# UNITED STATES PATENT AND TRADEMARK OFFICE

10/595,098

<b>Office Action Summary</b>	<b>Application No.</b> 10/595,098	<b>Applicant(s)</b> MAKINO, TOSHIKAZU	
	<b>Examiner</b> KRISTINA FULTON	<b>Art Unit</b> 3673

## **DETAILED ACTION**

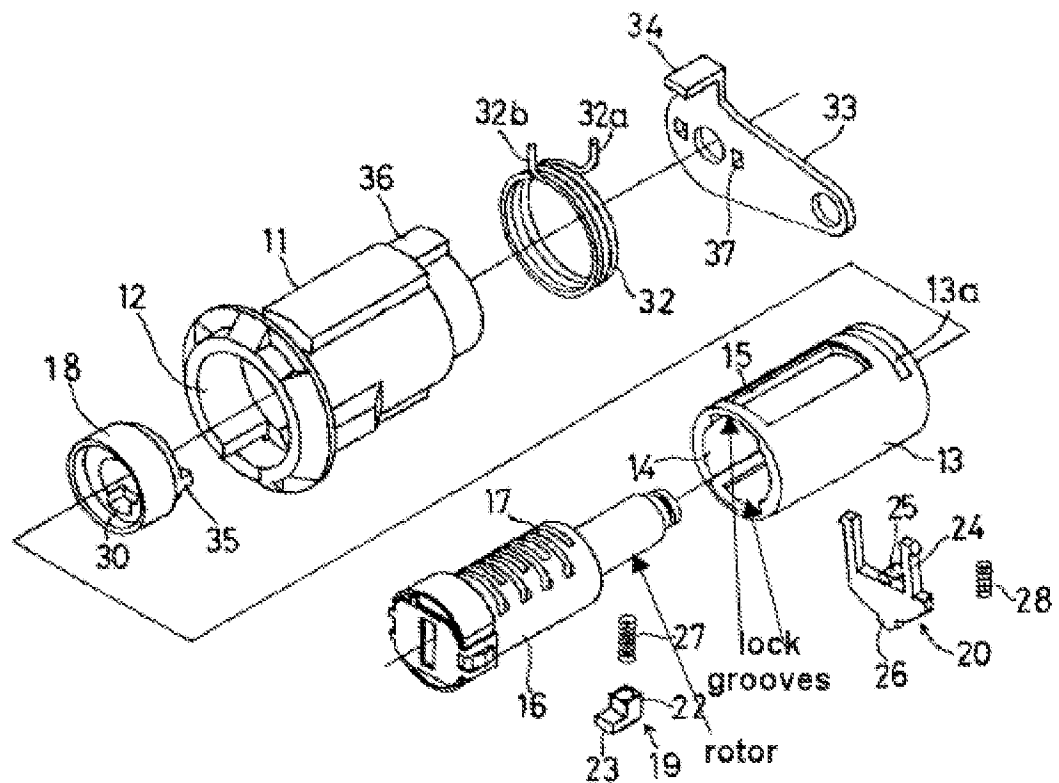
Regarding claim 1, Keiichi shows a cylinder lock comprising a cylindrical sleeve(13) which is turnably placed in a holder (11) and in which lock grooves (see illustration below) are formed on an inner circumferential surface; a cylindrical cylinder (16) which is turnably placed in the sleeve and on which a plurality of tumbler insertion holes (17) extending in a direction orthogonal to an axial direction are formed; a plurality of tumblers (not shown but are inherent since they tumbler holes are shown) which are reciprocally placed in the tumbler insertion holes of the cylinder, which are engaged with the lock grooves in an advanced position, and which are retracted and disengaged from the lock grooves with insertion of an authorized key (see abstract); a rear rotor (see illustration below) of which an at least part is turnably placed in the cylinder (when the cylinder turns the rotor turns); a connecting member (19) which is placed in the movable in radial directions between a connected position in which the rear rotor and the cylinder are connected to each other and a non-connected position; and a connection releasing member (20) which is provided so as to be positioned on an outer circumference of the connecting member and so as to be movable in radial directions relative to the sleeve and which travels radially and presses and moves the connecting member to the non-connected position when the sleeve that receives a turning force of the cylinder by virtue of engagement of the tumblers with the lock grooves turns relative to the holder. See the Keiichi device below.

**Fig. 11**

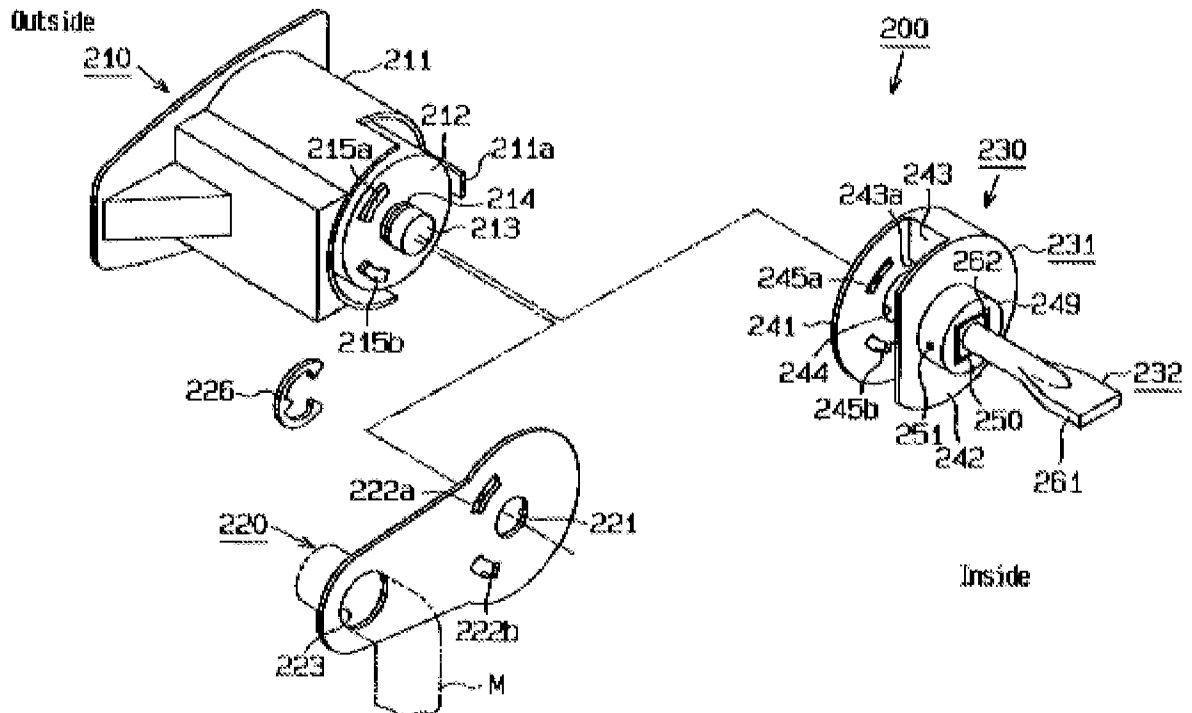
Although Keiichi shows applicant's inventive concept, Keiichi fails to include a rotor having a container portion. Katagiri shows that this is well known in the cylinder lock art. Katagiri shows a rear rotor (200) turnably placed in a cylinder (210) having a container portion (230) formed in the part placed in the cylinder. See the Katagiri device below.
